ADDENDUM NO. 2

A NEW OFFICE BUILDING FOR
FRONT ROH ENTERPRISES

COMMISSION NO. 2008-17

April 24, 2009

NEW OFFICE BUILDING FOR FRONT ROH ENTERPRISES
 9441 FENTON ROAD - MUNDY TOWNSHIP, MI
 TED HU ASSOCIATES, INC - GRAND BLANC, MI
 ADDENDUM No. 2 - APRIL 24, 2009 - DWG SK-M1 OF 1

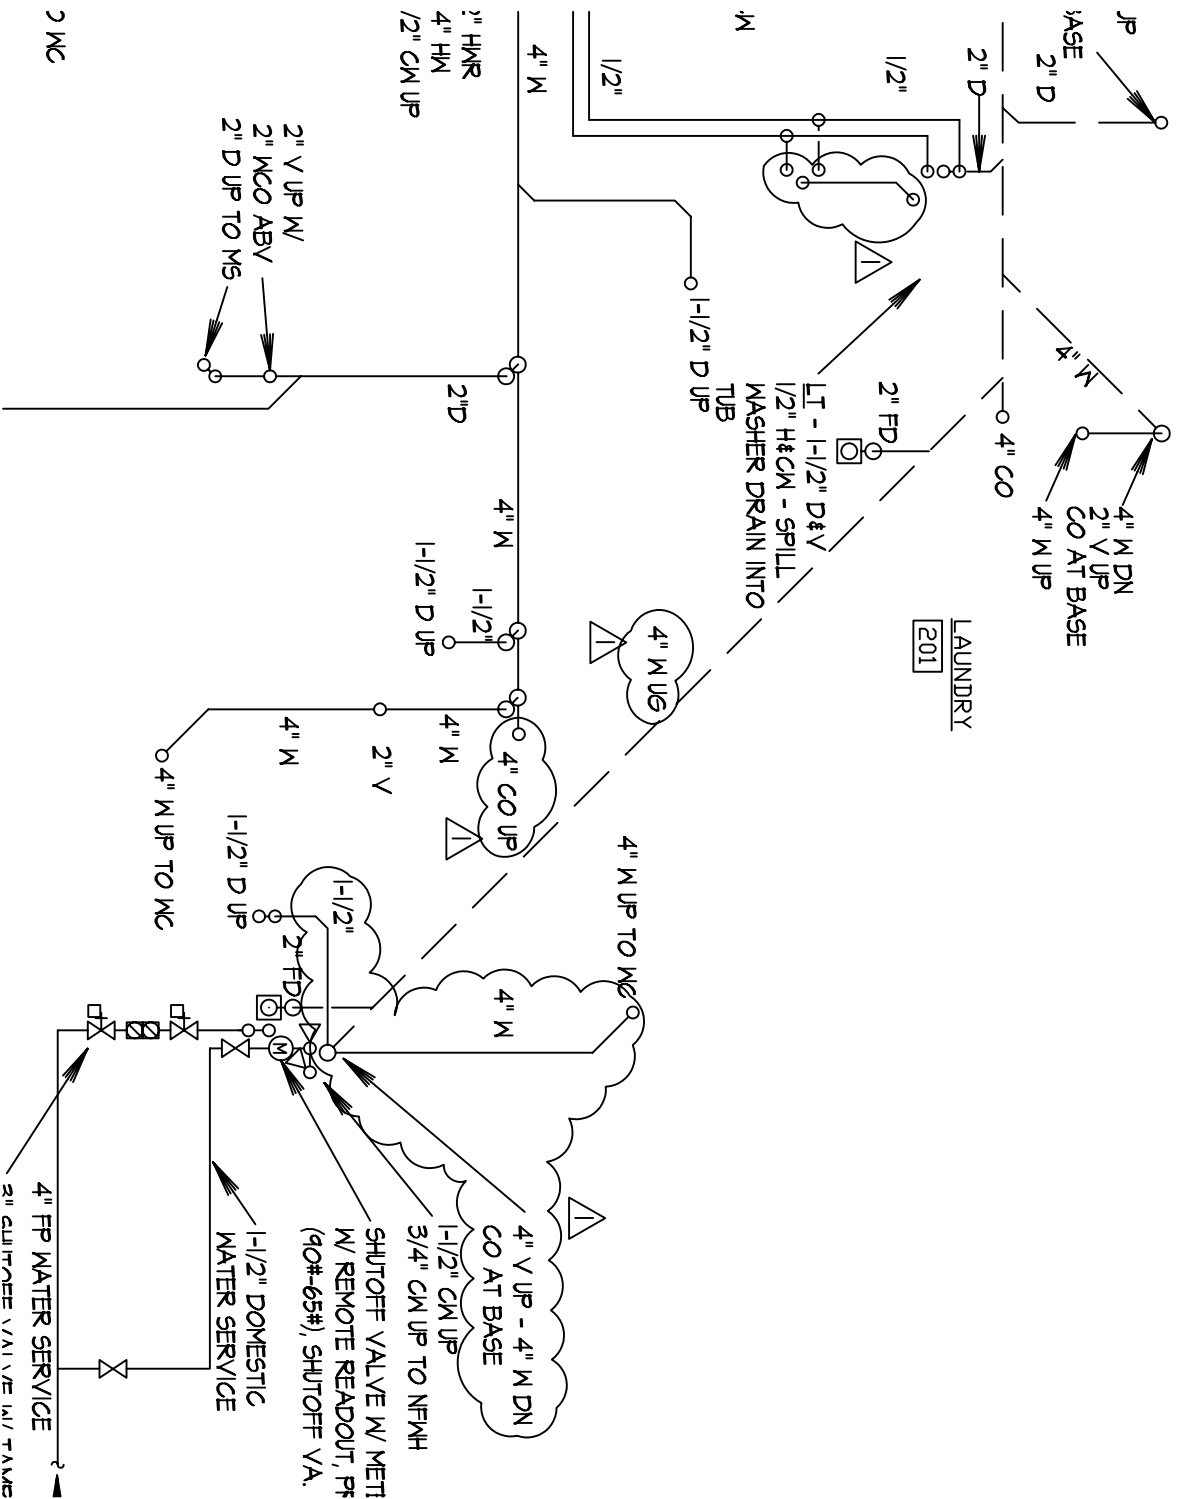
- d. Revise piping as shown on attached Sketch SK-M1.
- 2.03 Revise Sheet M-3 – Floor Plan – Plumbing – as follows:
 - a. Furnish and install point-of-use TWV's at Lav's in Toilet-103, Toilet-108, and Toilet-110.
